QUALITY ASSURANCE -- NON-CONFORMANCE REPORT

Location: Changxing Island, Shanghai, China**Report No:** NCR-000895**Prime Contractor:** American Bridge/Fluor Enterprises, a JV**Date:** 23-Nov-2010**Submitting Contractor:** Zhenhua Port Machinery Company, Ltd (ZPMC), Changxing Island**NCR #:** ZPMC-0857**Type of problem:**

Reference Description: Weld Procedure Requirements for New Welds Not Followed**Description of Non-Conformance:**

To: AMERICAN BRIDGE/FLUOR, A JV **Date:** 24-Nov-2010
 375 BURMA ROAD
 OAKLAND CA 95607 **Contract No:** 04-0120F4
 04-SF-80-13.2 / 13.9
Dear: Mr. Charles Kanapicki **Job Name:** SAS Superstructure
Attention: Mr. Thomas Nilsson Project/Fabrication Manager **Document No:** 05.03.06-000852
Subject: NCR No. ZPMC-0857
Reference Description: Weld Procedure Requirements for New Welds Not Followed

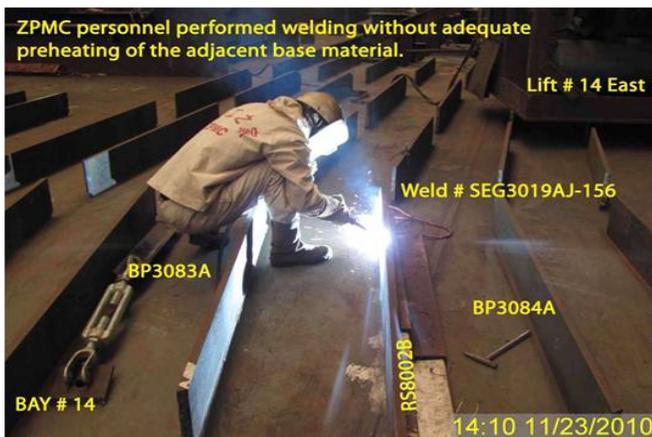
- ZPMC personnel performed welding for the fillet weld between "I" stiffener and bottom panel without adequate preheating of the adjacent base material.
- During the welding This QA Inspector observed a 140 degree Celsius Tempstick did not melt when applied to the adjacent base material.
- Weld number identified as SEG3019AJ-156
- Rib stiffener identified as RS8002B
- Bottom plate identified as BP3084A and BP3083A
- BP3083A and BP3084A are designated on the approved shop drawings as Seismic Performance Critical Members (SPCM).
- The welding performed with Flux Cored Arc Welding (FCAW) process.
- Area was being preheated using electric strip heaters.
- OBG Lift 14 East in bay # 14

- ZPMC did not perform PWHT after complete weld repair before the temperature falls below the preheat temperature on the weld joint between "I" rib stiffeners (RS3214C) to the plate (PL3279A).
- This QA Inspector observed a 140 degree Celsius Tempstick did not melt when applied to the adjacent base material

- Weld number identified as VP3007A-001-016, 004, 055
- PL3279A designated on the approved shop drawings as Seismic Performance Critical Members SPCM)
- The welding performed with Shielded Metal Arc Welding (SMAW) process
- This welds are detailed as a complete joint penetration (CJP), Fracture critical weld (FCW)

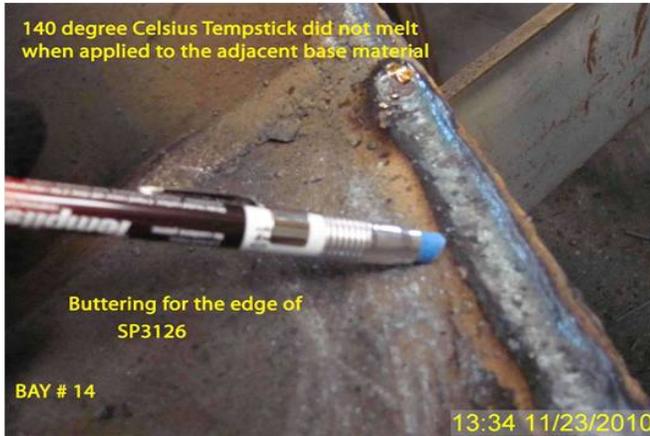
- ZPMC personnel performed buttering on the edge of the plate SP3126 without adequate preheating of the adjacent base material.
- This QA Inspector observed a 140 degree Celsius Tempstick did not melt when applied to the adjacent base material
- The welding performed with Shielded Metal Arc Welding (SMAW) process
- Did not appear any electric strip heaters or torch

See attached photographs for additional detail.

DETAIL "AJ"
(DEVELOPED, ROTATED @ SOUTH SIDE)
(ON SEG3019A)

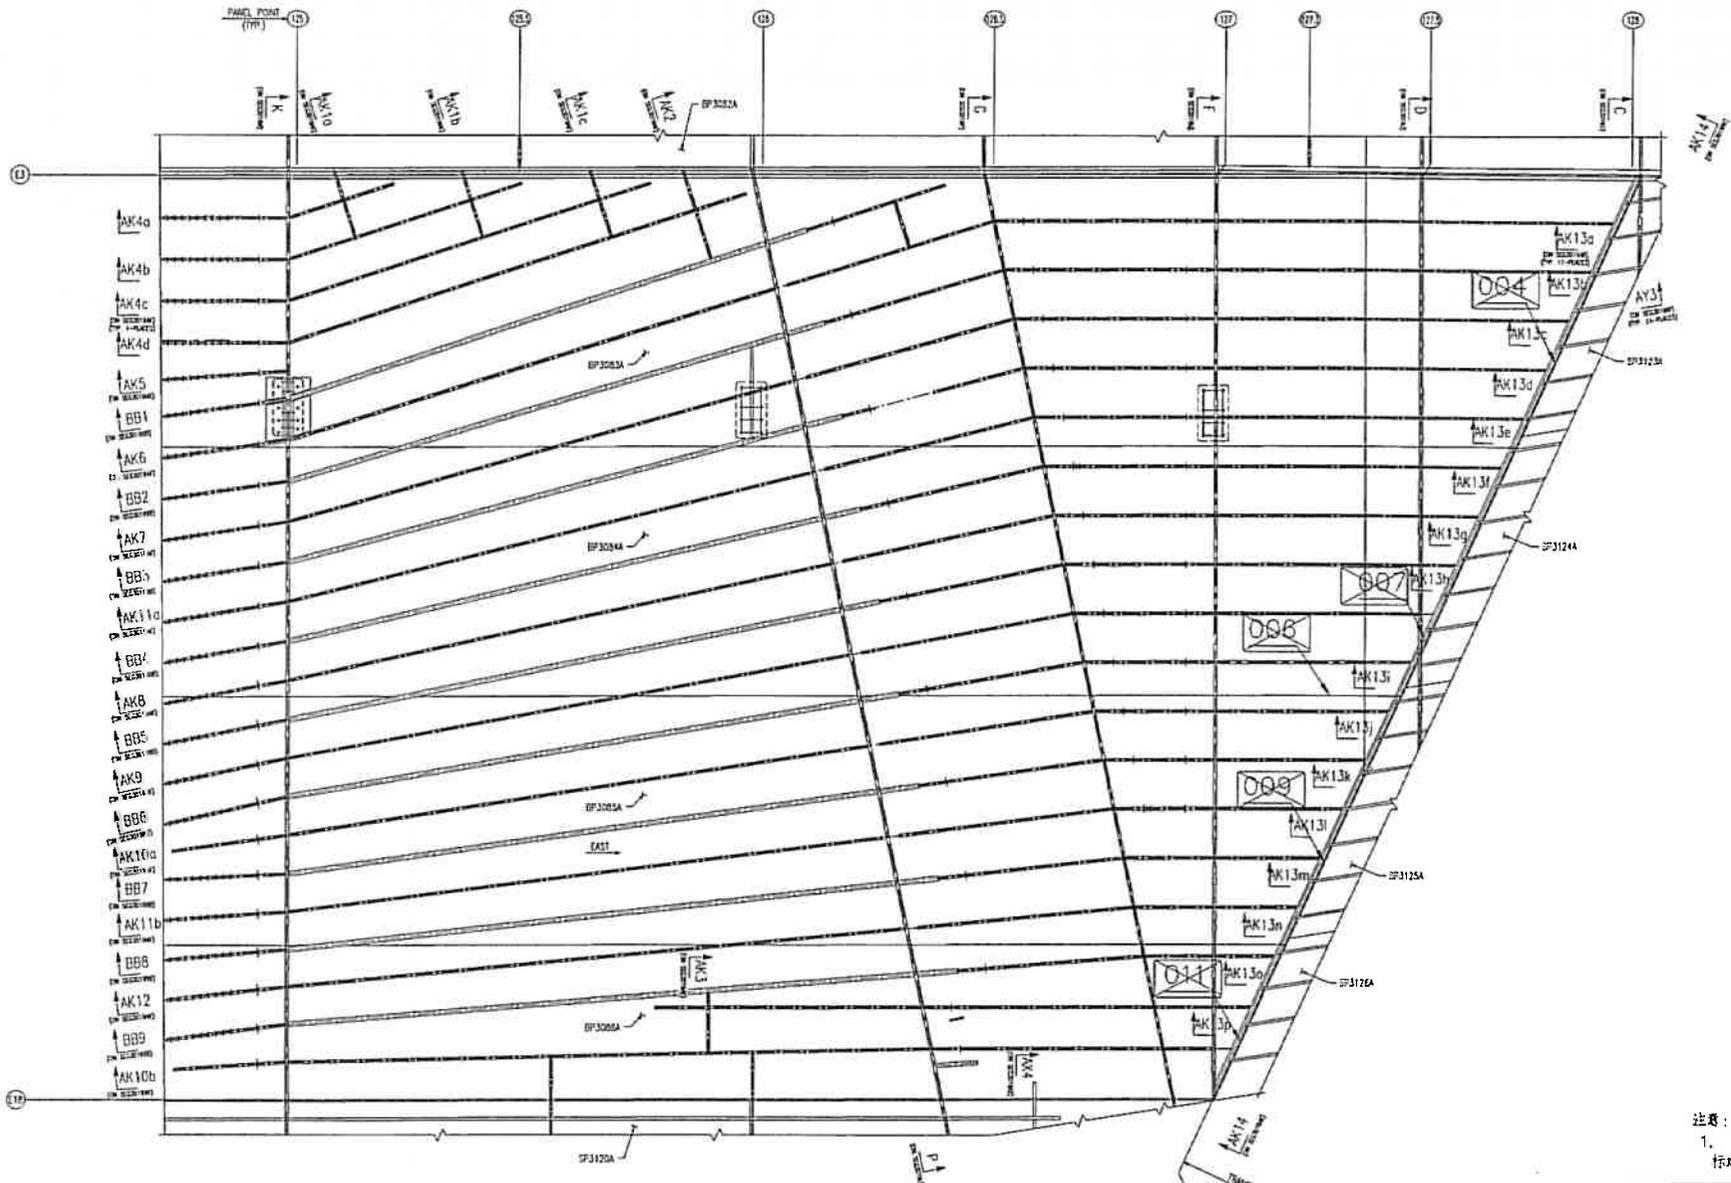
Reference Resolution: ZPMC is providing acceptable NDT of the weld referenced in the NCR and requests closure of this NCR. Weld ID SEG3019AJ-156 does not exist.
